PROJECT: Summerlin West 1/2 - Kestrel Creek Avenue (Street 1)

CITY OF LAS VEGAS INTER-OFFICE MEMORANDUM

Drainage Study for:

Summerlin West V22 – Kestrel Creek Avenue (Street I)
(from Desert Foothills Drive to Kettle Ridge Drive <Street J>)

"KCA" STA. 17+64 SEE SHEET 14

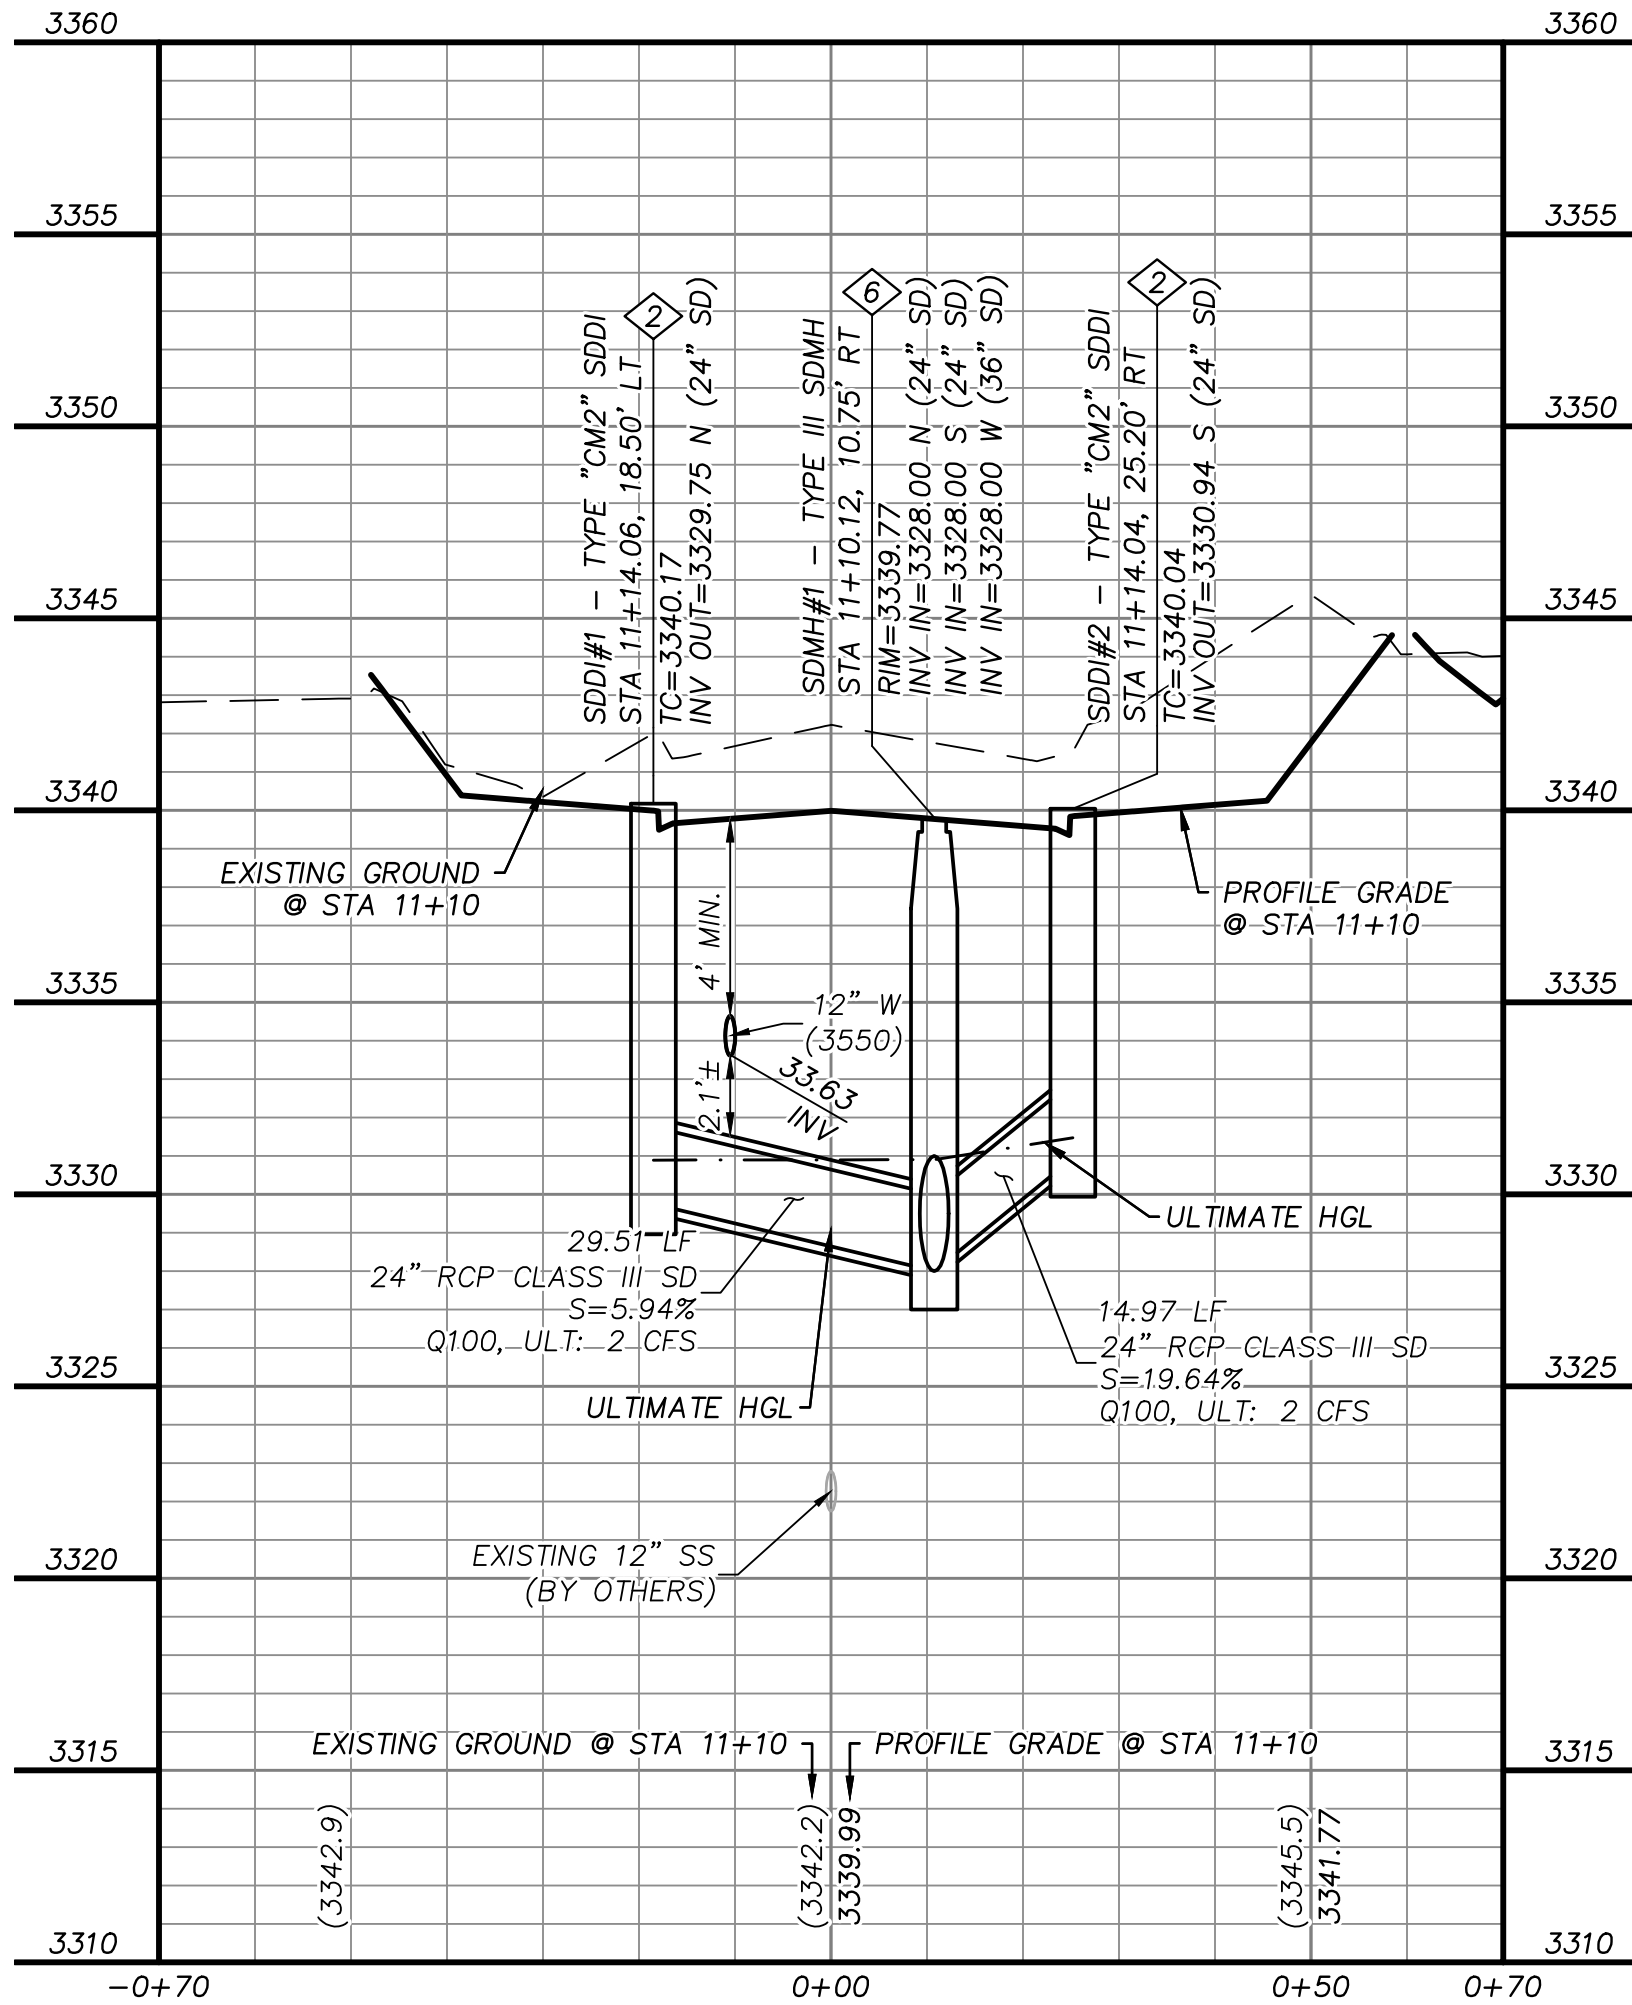
The response that all drop inlets had been modified to less than 10' in depth was found not true. Per **Sheet 21/31 (Storm Drain Lateral Profiles)**, proposed inlets SDDI #1, SDDI #3 and SDDI #5 are schematically shown to be deeper than 10'. This must be resolved prior to the final approval of the study.

On Sheet 21/31, since you did not label the depth of the inlets clearly, I went on visually measuring the depths from the profile and found that the inlets are more than 10' deep from the flow line to the bottom. So label the depth of each inlet clearly and revise the profile to visually convincing.

The response that all drop inlets had been modified to less than 10' in depth was found not true. Per Sheet 21/31 (Storm Drain Lateral Profiles), proposed drop inlets SDDI #1, SDDI #2, and SDDI #4 are schematically shown to be deeper than 10'. This must be resolved prior to the final approval of the study.

Drop Inlet	Top of Curb	Flow Line	Invert	Depth
SDDI #1	3440.17	3439.67	3329.75	9.92'
SDDI #3	3383.94	3383.44	3373.94	9.50'
SDDI #5	3383.94	3383.44	3373.94	9.50'

Please review the above information and methodology and let us know if we can issue a formal supplement if a formal supplement is necessary to clear up this discrepancy and hopefully move closer to conditional approval.
